**5517D-05B**

**S E R V I C E N O T E**

5517D, 5517D-C19, 5517DN06, N07 and N13 Laser Heads

**Controller Board A3F1 Nuisance blows**

Picture shows the 0.63A TH fuse installed.

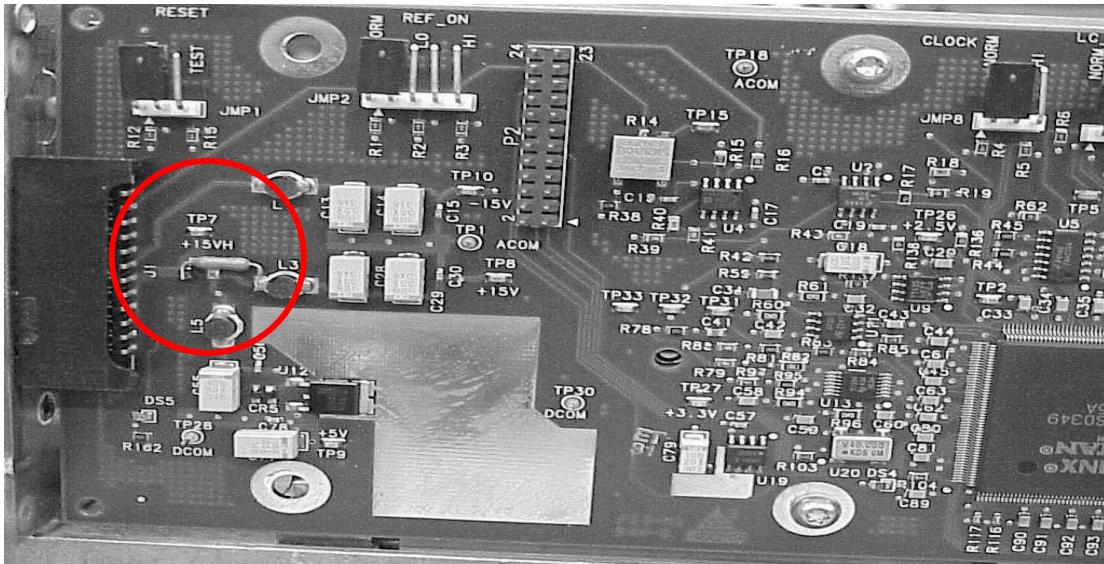
Agilent has identified some applications in which there is nuisance blows of the fuse (A3F1) on the laser controller board (05517-60031). This is a secondary fuse; the main fuses are not affected.

Nuisance fuse blowing is sometimes seen when the laser head is operated in a high temperature environment with limited to no air circulation around the unit. This condition causes very high temperatures inside the laser, greatly reducing the operating margin for the fuse.

In some applications, customers have elevated the ambient temperature surrounding Agilent's Laser Heads. In some cases, customers have added a cover over the Laser Head in which the ambient temperature raises, or they have restricted the airflow around the Laser Head. Both of these cases have lead to the nuisance blows of the fuse on the laser controller board.

We recommend that you remove the 0.5A surface mount fuse and replace it with a 0.63A through hole fuse (see picture below). In order to do this, bend the leads on the fuse to be able to attach the through hole fuse from the left fuse pad to L3. Then solder the fuse in place. After replacing the fuse the laser head needs to be powered up to ensure the unit is working. Additional test are optical power and split frequency tests. No adjustments are needed. Also, to identify laser heads that have had the fuse replaced, we recommend a label be placed on the rear panel (see picture below).
